City of Portland Design Commission

Design Advice Request

SUMMARY MEMO

Date: July 21, 2022
To: Dave Otte, Holst Architects
From: Tim Heron, Design / Historic Review Team
(503) 823-7726, tim.heron@portlandoregon.gov
Re: EA 22-144886 DA – Hollywood Transit Center HUB Housing
Design Advice Request Commission Summary Memo – July 7, 2022

2. Massing and Articulation

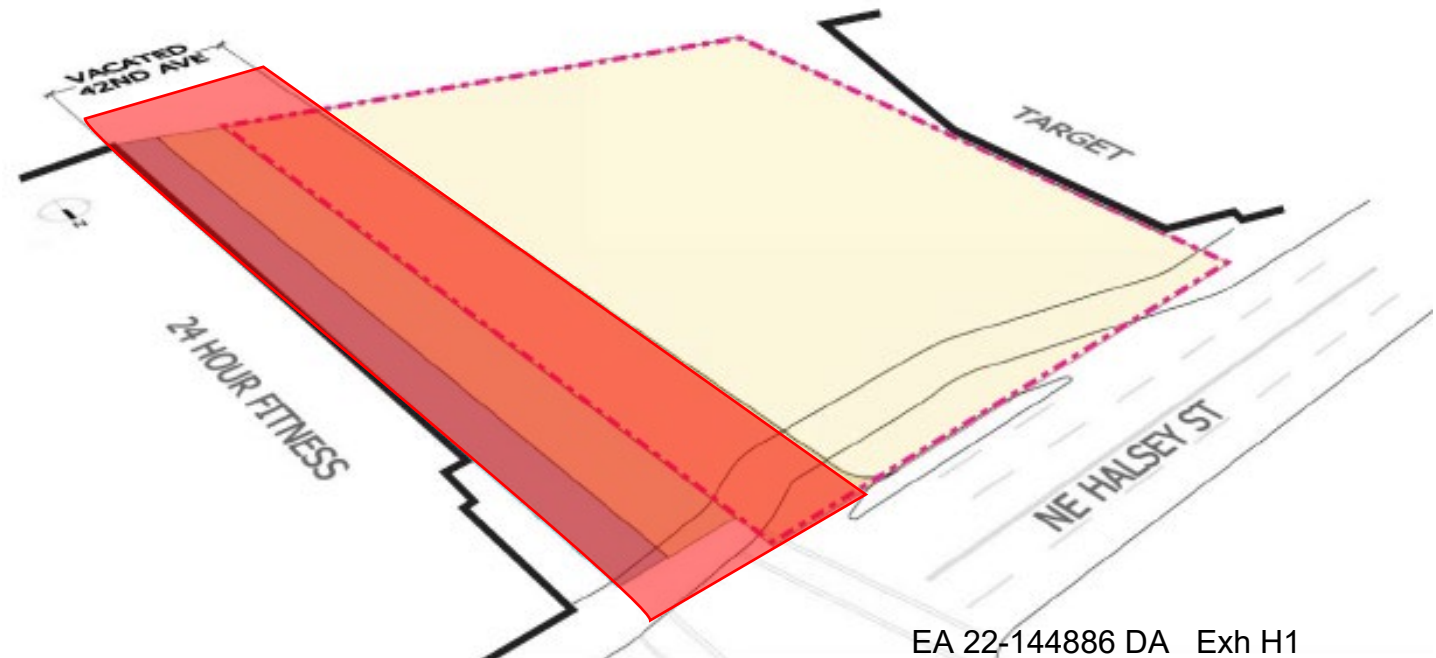
- a. L-shape building created due to Difficult to Develop Area boundaries for anticipated funding for affordable housing
 - o Current design assumes NE 42nd Avenue ROW street vacation, but also blocks potential alternative access to Sullivan's Gulch Trail, possibly also BES

b. Sculpting/ Articulation opportunities

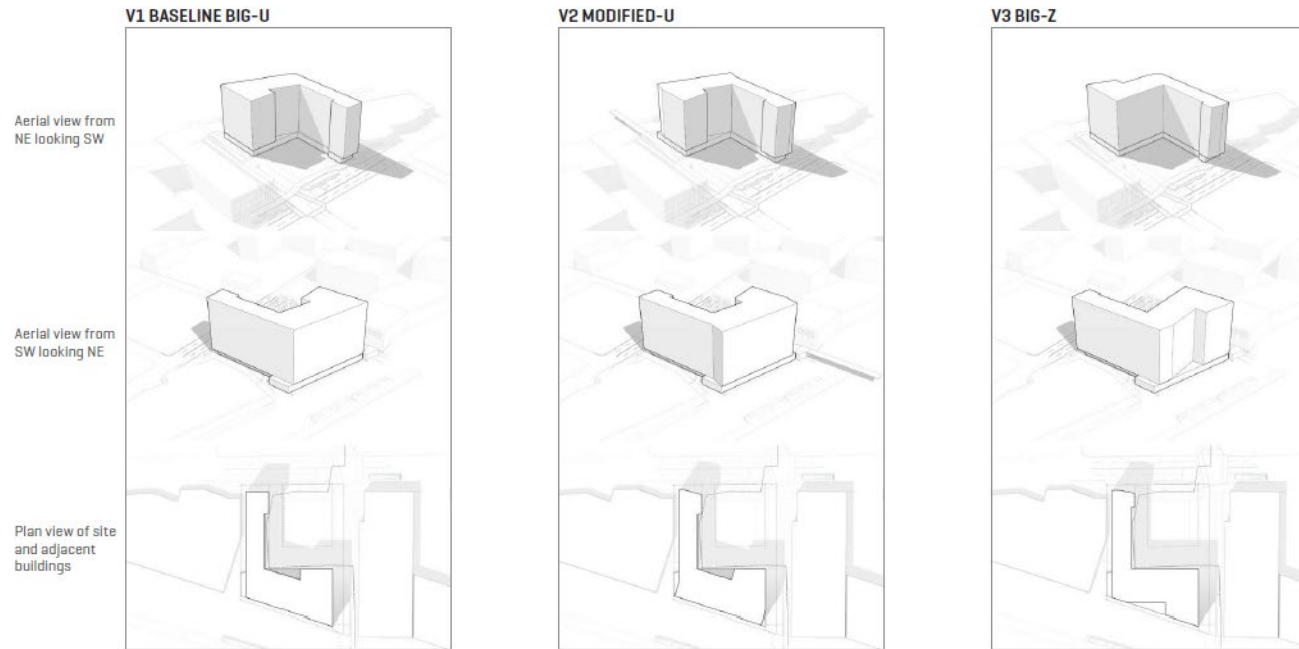
- While height and FAR are allowed, the building massing and articulation can be manipulated to better respond to Area Context

3. Outdoor Area Requirement

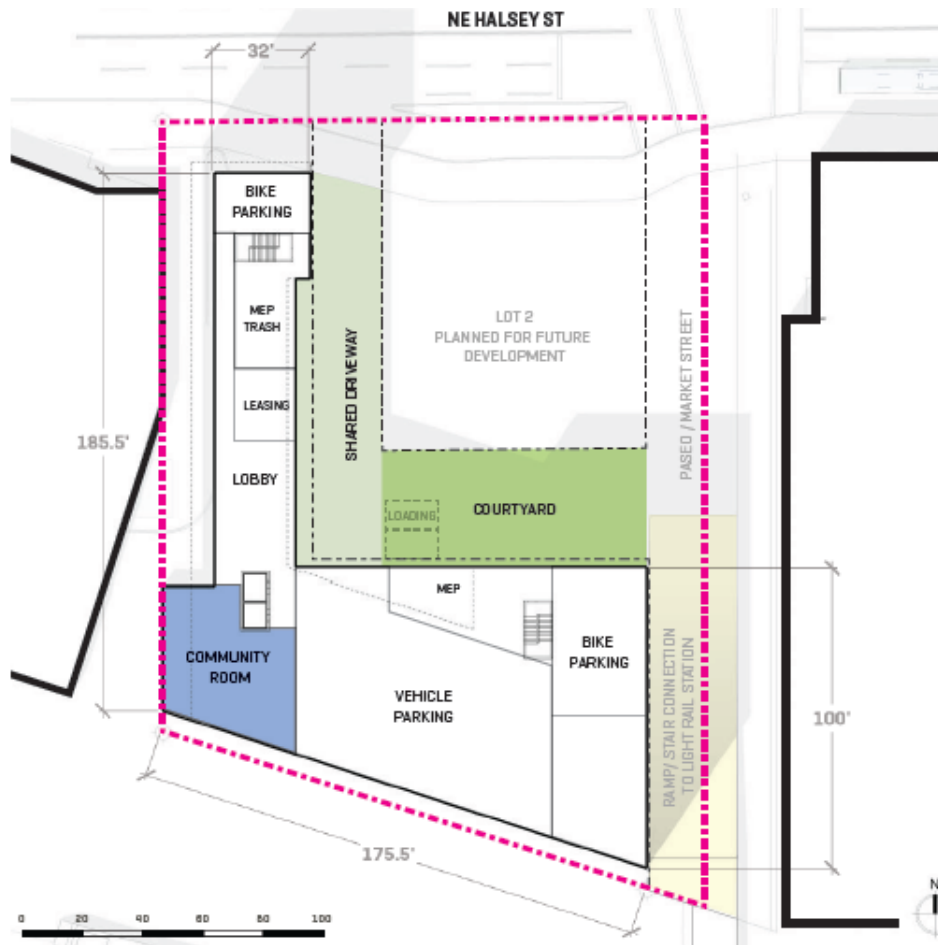
- a. Required Outdoor Area not met, triggers Modification
 - o *Modification 33.130.228 Required Outdoor Areas, for sites larger than 20,000 SF, 48 SF of outdoor area per unit is required, or 9,648 SF; 8,700 SF proposed*
- b. Courtyard design represents 1/3 of the outdoor area requirement
 - o Adjacent to proposed inactive ground floor uses
 - o Loading spaces proposed within required outdoor area
 - o Adjacent to future development site
- c. Balconies and/ or more interior and rooftop outdoor spaces opportunities
